Apex House- Plymouth Grove

Pre- Commencement Planning conditions

Condition 9

Roscoe Comments – Provided 26th January 2026.

DRAWING No:	REV:
P662-ROS-XX-XX-DR-C-0501	P07

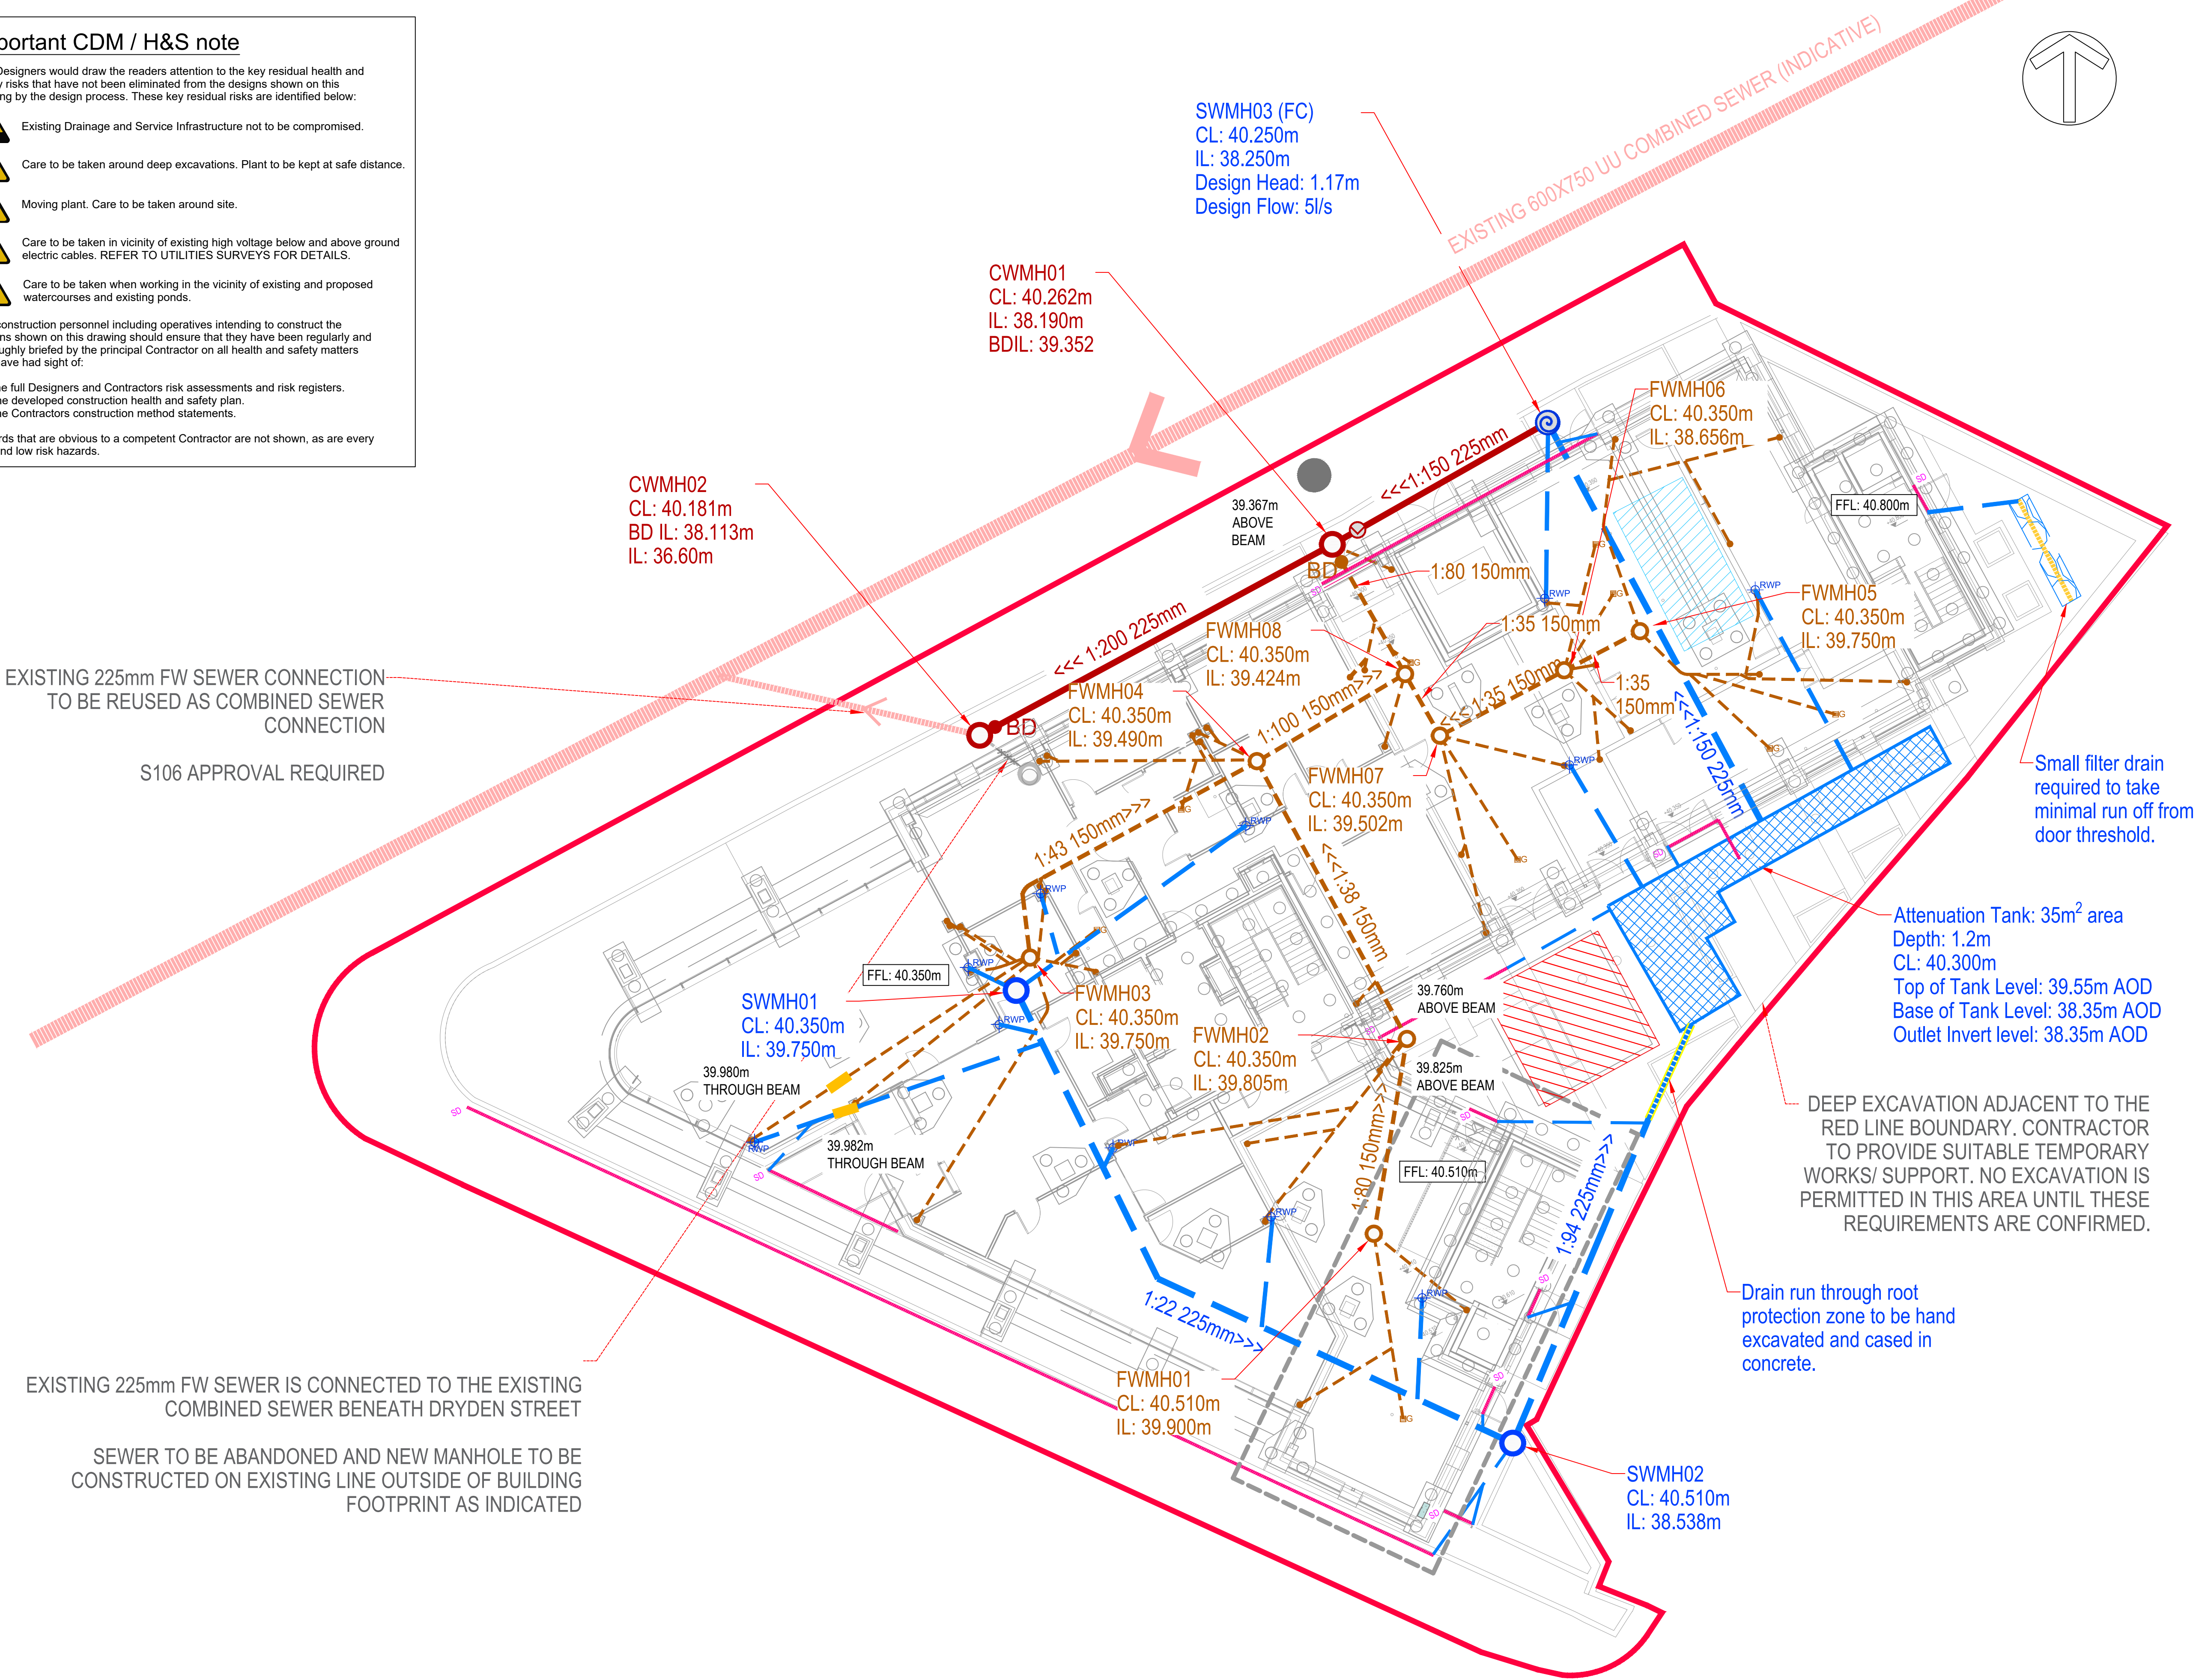
1. A finalised drainage layout showing all components, outfalls, levels and connectivity.

The finalised drainage layout has been attached in Appendix A- this revision includes all components, outfalls, levels and connectivity.
